APPEAL SUMMARY

Appeal ID: 31463	Project Address: 3238 NE 20th Ave
Hearing Date: 4/12/23	Appellant Name: Dave Spitzer
Case No.: B-003	Appellant Phone: 503 335 9040
Appeal Type: Building	Plans Examiner/Inspector: Roza Malekzadeh
Project Type: residential	Stories: 2 Occupancy: R-3 Construction Type: V-B
Building/Business Name:	Fire Sprinklers: No
Appeal Involves: Erection of a new structure	LUR or Permit Application No.: 23-016760-RS
Plan Submitted Option: pdf [File 1]	Proposed use: adu

PAYNE GARAGE / ADU
3238 NE 20TH AVE
PORTLAND, OR

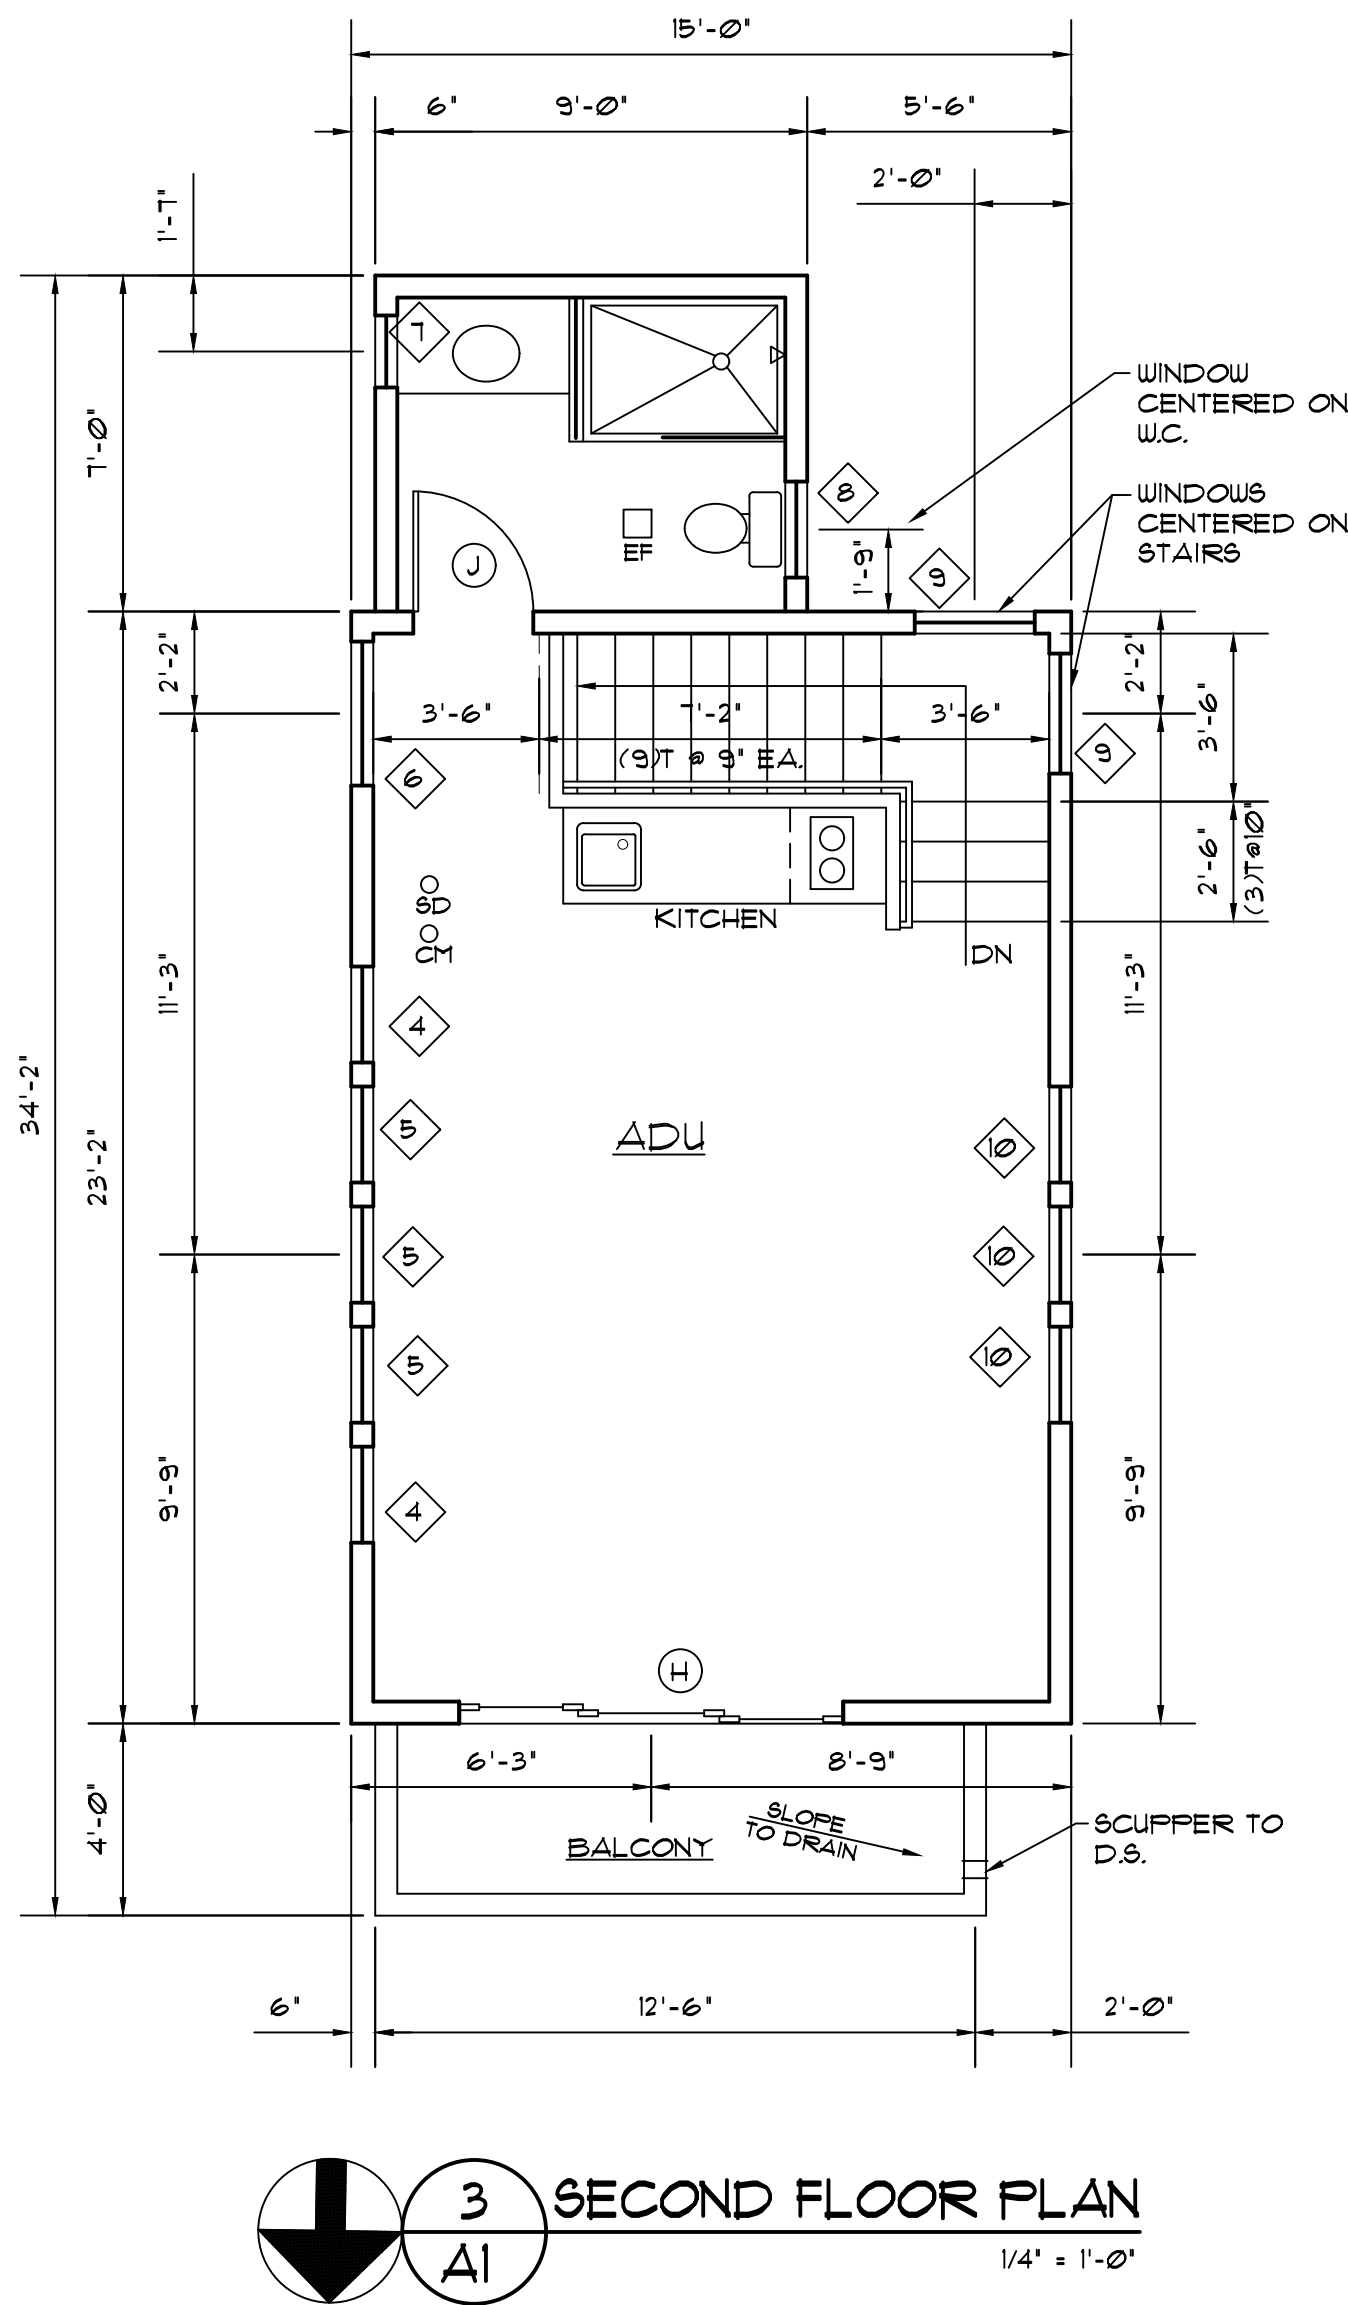
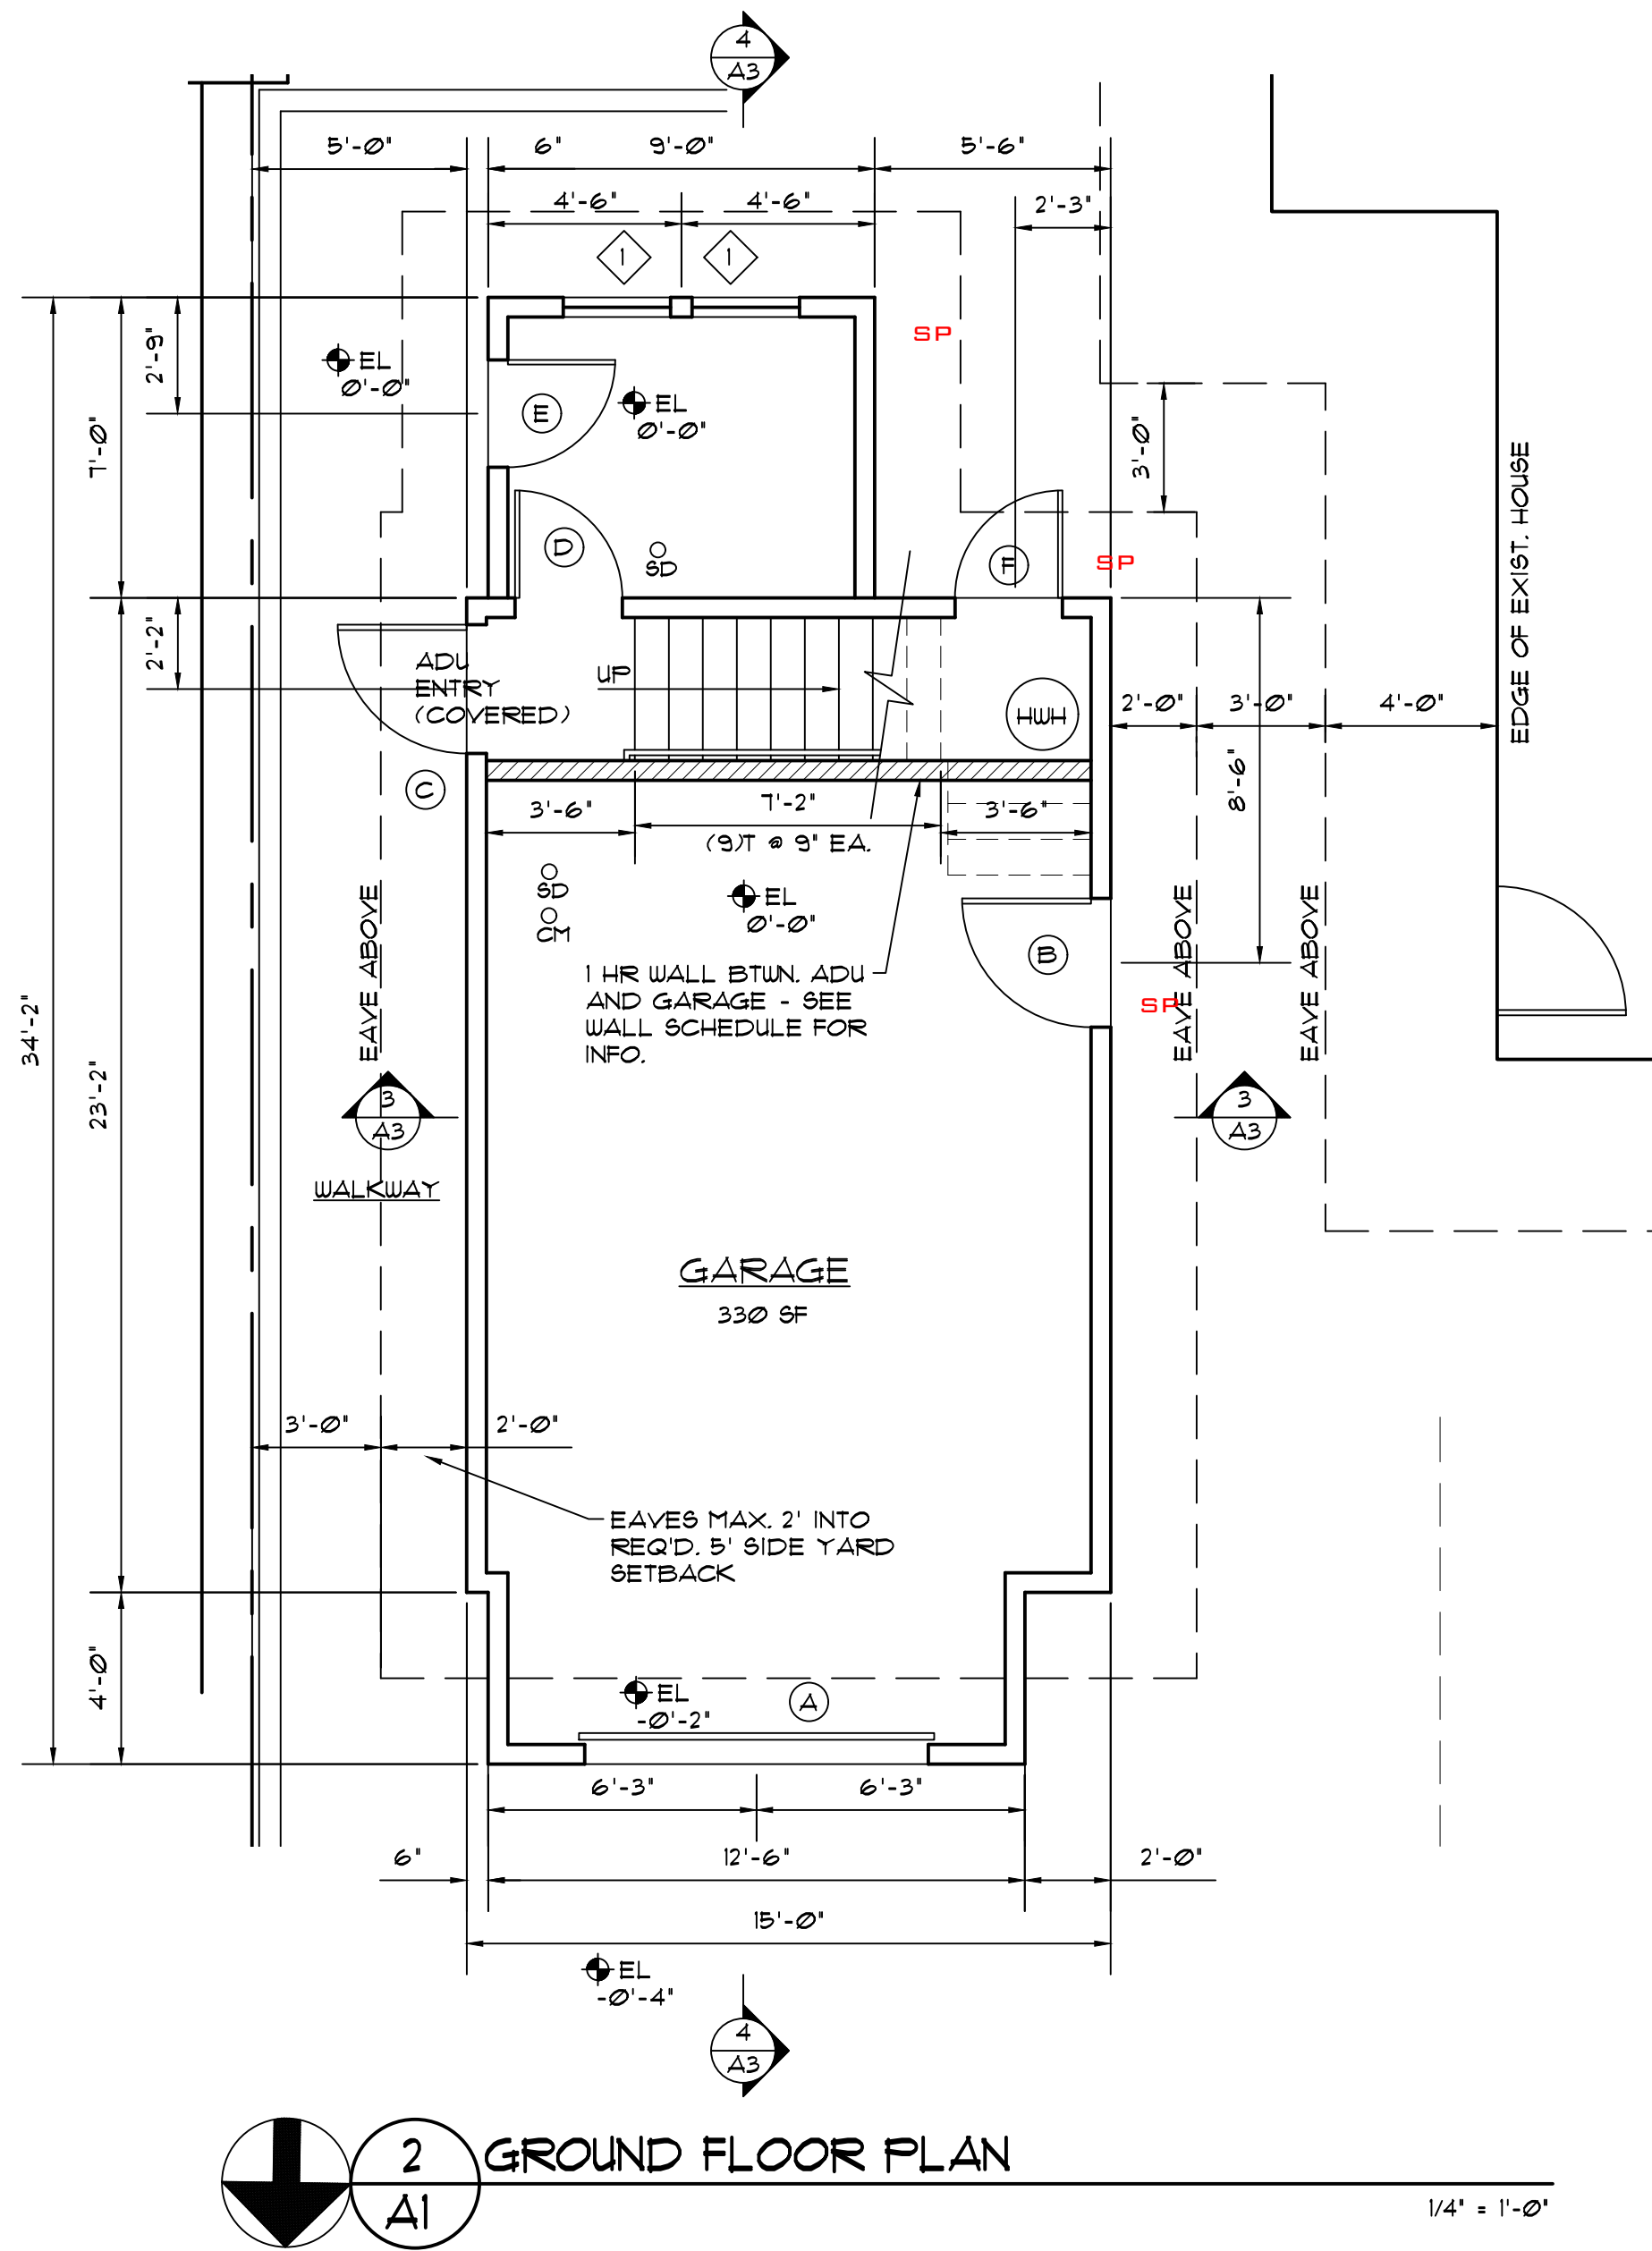
Code Section R302.3

Requires Requires eaves to be a minimum of 2' from the property line.

Code Modification or Alternate Requested We are requesting the new ADU to have fire rated eaves just 1' from the property line and to maintain the existing non-rated eaves of the house 2' from the property line.

Proposed Design The existing house has very deep - 4' wide eaves. The existing eaves are approximately 20' above grade.

We are building and ADU ontop of a garage (all new). We are in an historic district so using similar eaves to existing is important. While the existing house is very large and has 4' deep eaves - the new ADU structure is quite a bit smaller so 2' eaves are more appropriate.

We are also very tight on the site - as drawn our structure is only 15' wide - so loosing 1' for the eaves is important to make the space functional.

Instead of having our eave for the ADU 2' from the imaginary property line - we'd like to be just 1' but then install sprinkler heads at roughly 10' o.c. at the underside of the eaves were the two structures abut.

Reason for alternative The site is very tight, architectural compatibility in this historic neighborhood is very important as well. Providing (3) sprinkler heads at the underside of the ADU eaves (which is lower than the main house eaves) will provide protection for both structures.

Proposed ADU with reduction in the minimum required West eave fire separation distance from two feet to one foot with partial eave sprinkler protection: Granted provided 13D sprinklers are provided throughout the ADU with one head in garage near side door and provided fire resistant treated sheathing or Type X gyp sheathing is used beneath non-frt sheathing at West eave.
